11. (SPUD-1386) Application by David Box to rezone 1612 and 1614 NW 17th Street from the SPUD-930 Simplified Planned Unit Development District, R-2 Medium-Low Density Residential District and Gatewood Urban Conservation District to the SPUD-1386 Simplified Planned Unit Development District and Gatewood Urban Conservation District. Ward 6.

Planning Commission Minutes
April 28, 2022

STAFF REPORT
The City of Oklahoma City
Planning Commission
April 28, 2022

A1.1

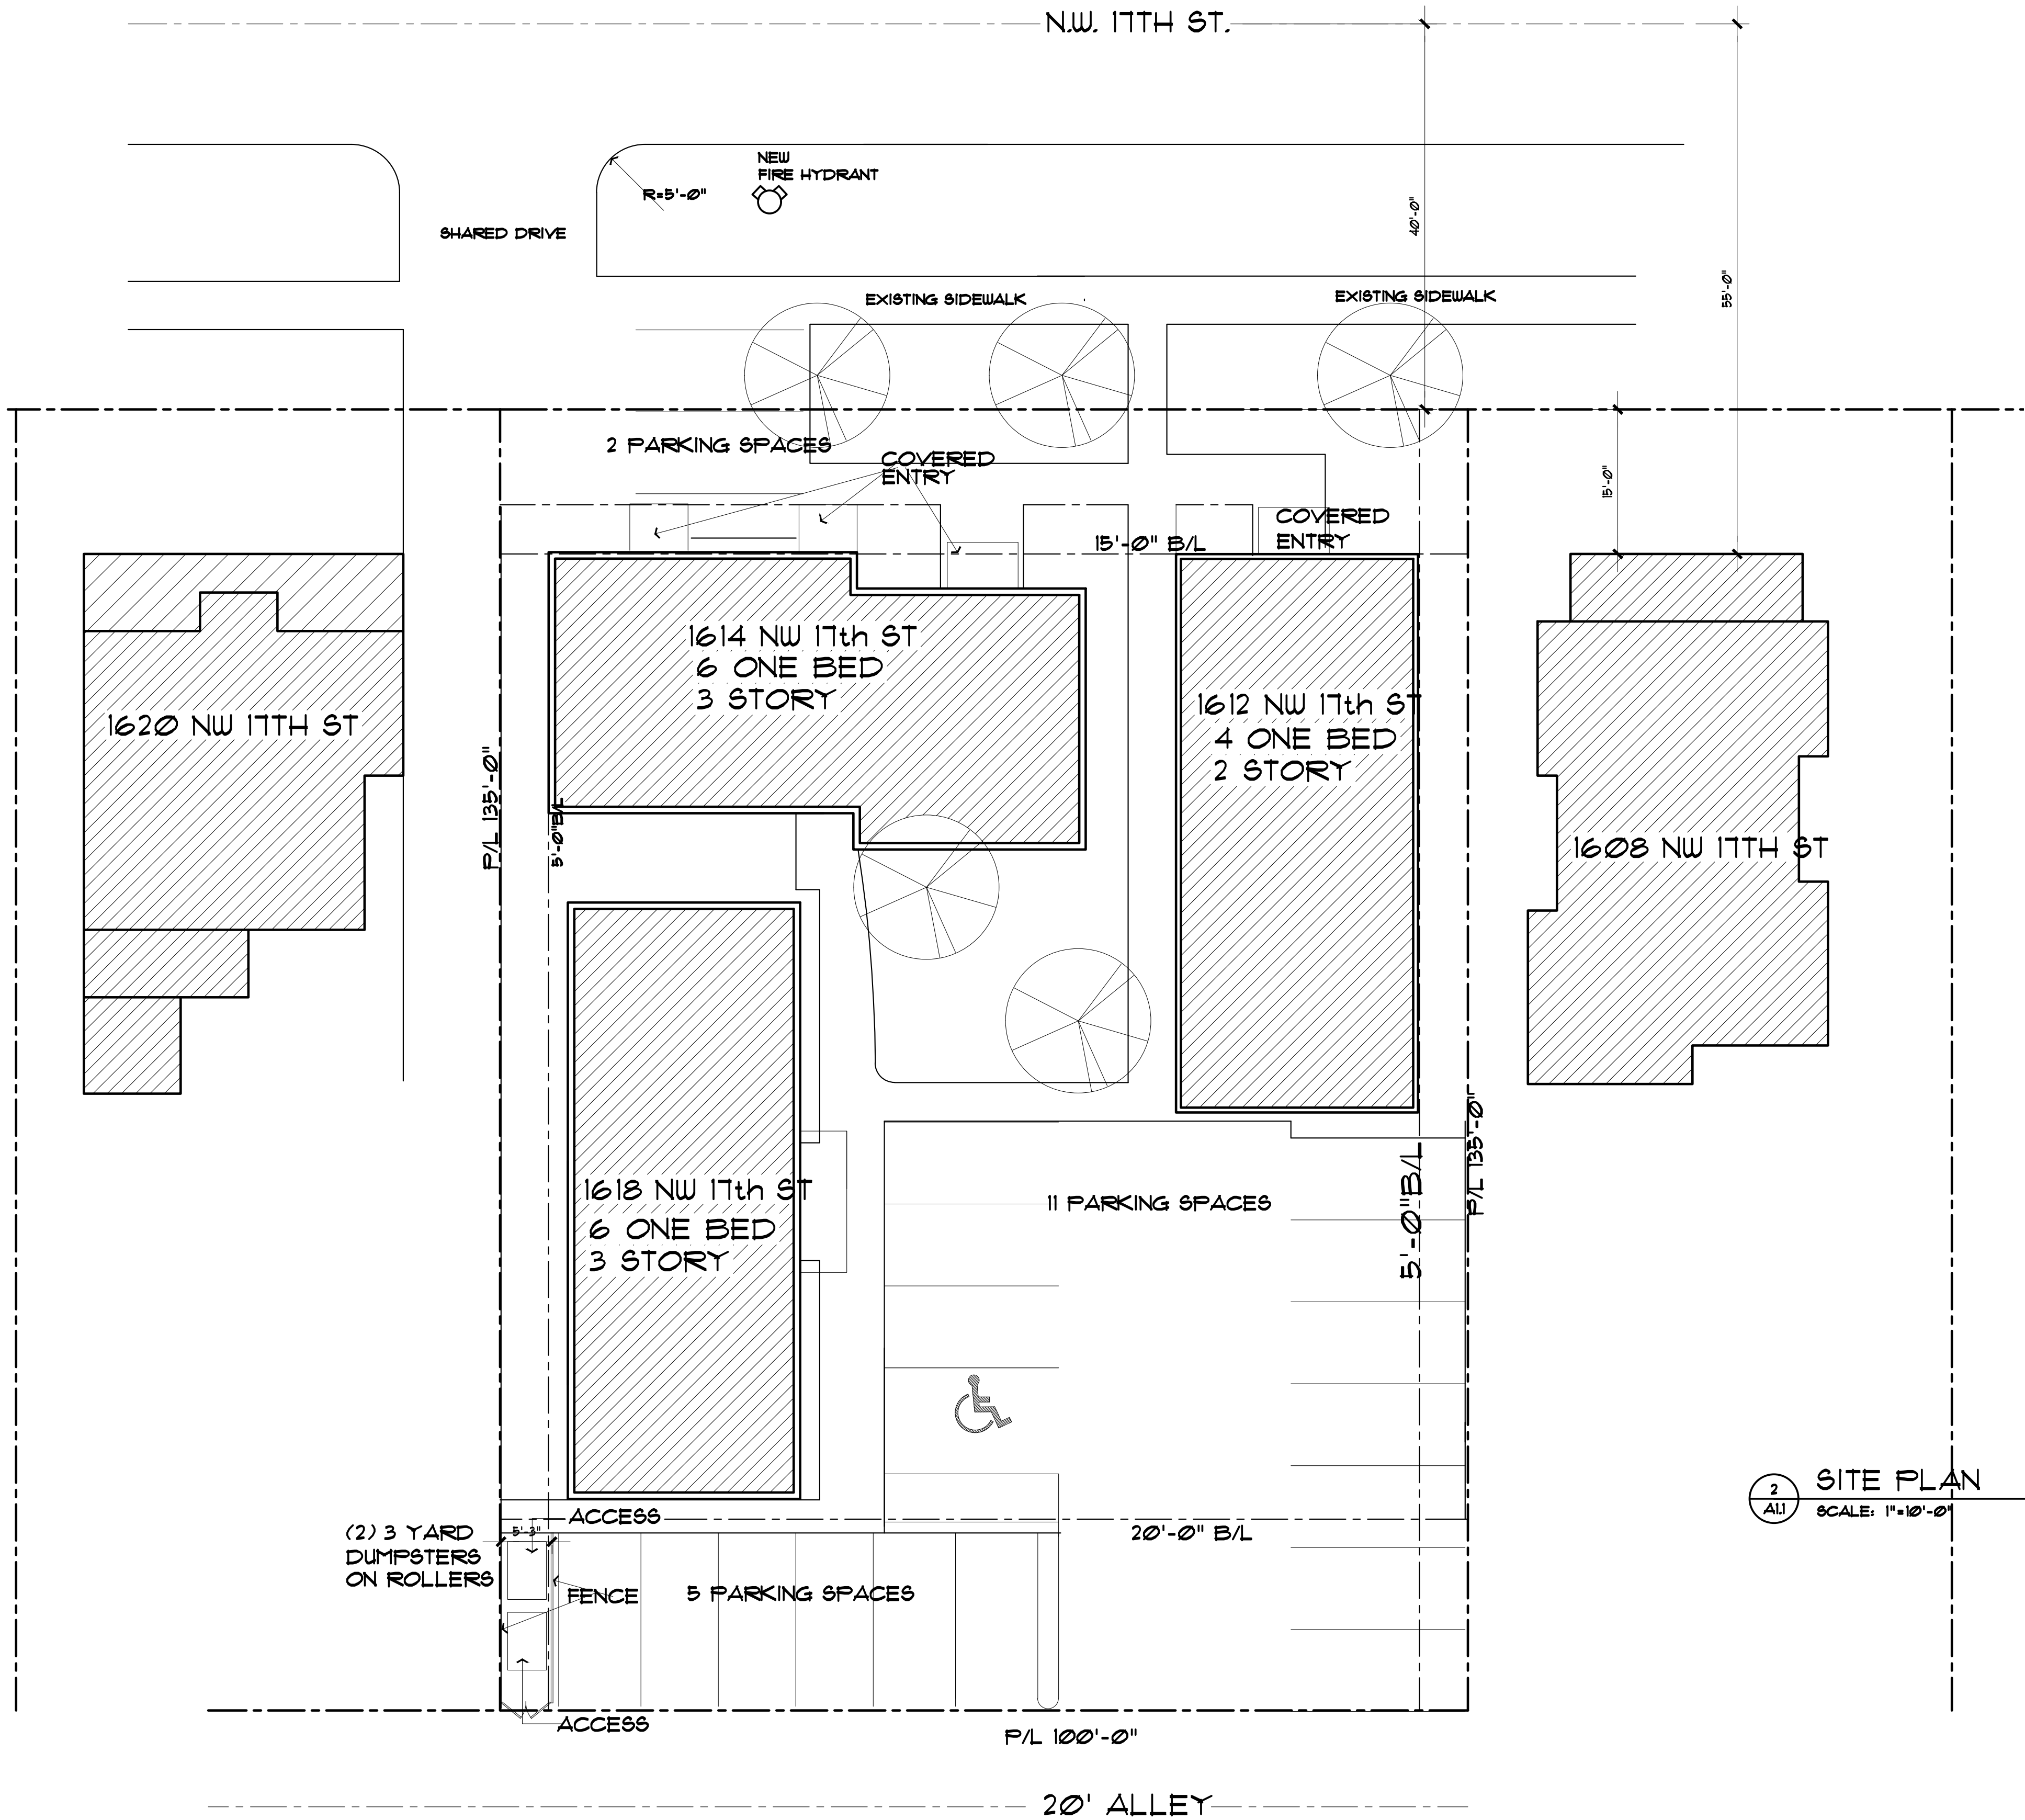
The existing home has one driveway. The SPUD proposes access from NW 17th Street and the alley but does not provide details about how many driveways would be allowed on NW 17th Street, nor how wide they will be. The exhibit indicates a shared drive with the property on the west and some parking in the front yard. The Gatewood UCD requires all parking for the R-4 District to be located in the rear yard. Driveways are limited to 12 feet for one-way and 20 feet for two-way.

The 0.32-acre subject site is located on the south side of NW 17th Street between N Blackwelder and N McKinley Avenues in the Gatewood Urban Conservation District. The east half of the subject site is developed with a home and zoned R-2. The west half of the property is undeveloped and zoned SPUD-930. Abutting on the west is a home also within SPUD-930, which was approved in January 2017 to allow the existing home and up to three more new homes - one behind the existing house and two more on the vacant parcel that is part of this application. The new SPUD seeks to demolish the existing home and construct up to 16 dwelling units (50 du/acre) in three apartment buildings. No details/renderings of proposed buildings were provided.

The proposal triggers potential building scale and site design issues, and is not consistent with the Urban Medium LUTA density range which calls for 10-40 du/acre. Conformance with the comprehensive plan would be strengthened by preserving the existing home, limiting the number of dwelling units to 12, and complying with the Gatewood UCD Regulations, attached for reference. Specifically, the front (north) setback should be 25 feet, the building height should be limited to 35 feet, all parking should be located in the rear (south), and new construction should be compatible with the neighborhood.

2. The number of dwelling units shall be limited to 12.
3. Building height shall be limited to 2 ½ stories and 35 feet.
4. The front (north) setback shall be 25 feet.

5. All parking shall be located to the rear of structures that front NW 17th Street.
6. A maximum of one driveway shall be allowed on NW 17th Street, subject to the Gatewood UCD width requirements.

7. Amend Architectural Regulations to state: “Buildings facing NW 17th St. shall be designed with front porches. ~~and/or balconies.~~”
8. Add to Architectural Regulations that “all primary residential structures shall have either a gable or hipped roof with at least a ten-degree pitch.”
